R44 SERVICE BULLETIN SB-116

SUBJECT: Ground Handling Wheel Support Reorientation

EFFECTIVITY: All R44-series helicopters. Earlier orientation of C719-1 wheel supports for outboard installation of ground handling wheels were factory-fitted on:

FIGURE 1
(C719-1 Supports oriented for inboard installation of ground handling wheels)

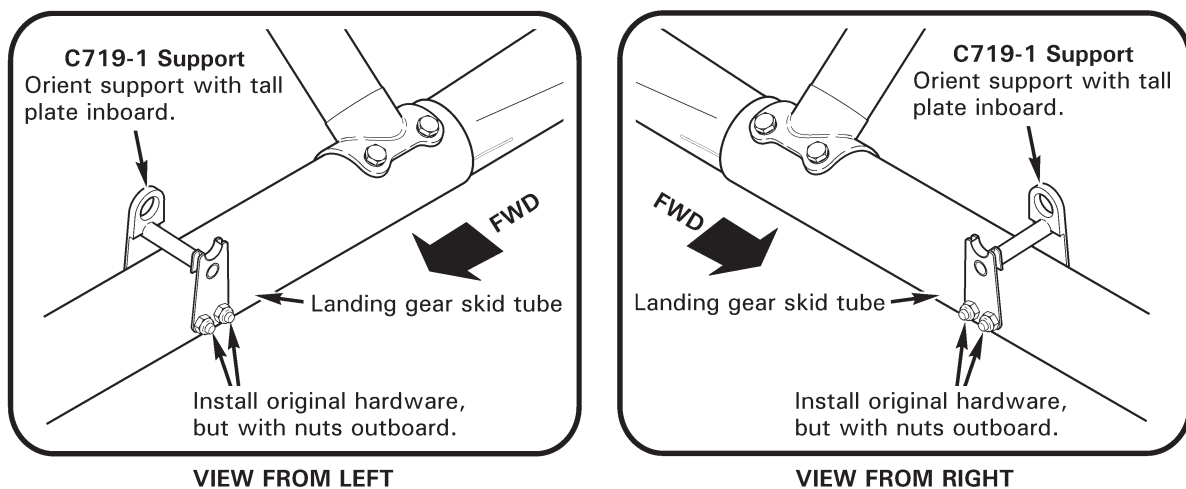
1. Refer to Figure 1. If C719-1 wheel supports are oriented for inboard installation of ground handling wheels, proceed to step 4.

2. Remove hardware securing C719-1 support to landing gear skid tube and remove support. Thoroughly clean and visually inspect support and skid tube at support attachment.
3. Orient support with tall plate inboard and install original hardware, but with bolt heads inboard for tire clearance. Special torque nuts to 70 in.-lb and torque stripe per R44 Maintenance Manual Figure 2-1. Repeat steps for opposite support.
4. Make appropriate maintenance record entries.
5. Modify earlier C063-1 ground handling wheels (handle is parallel to skid tube) for inboard installation per [R44 Service Letter SL-41](#), as desired. Current list price for KI-210 Modification Kit is \$125 (modifies two ground handling wheels).
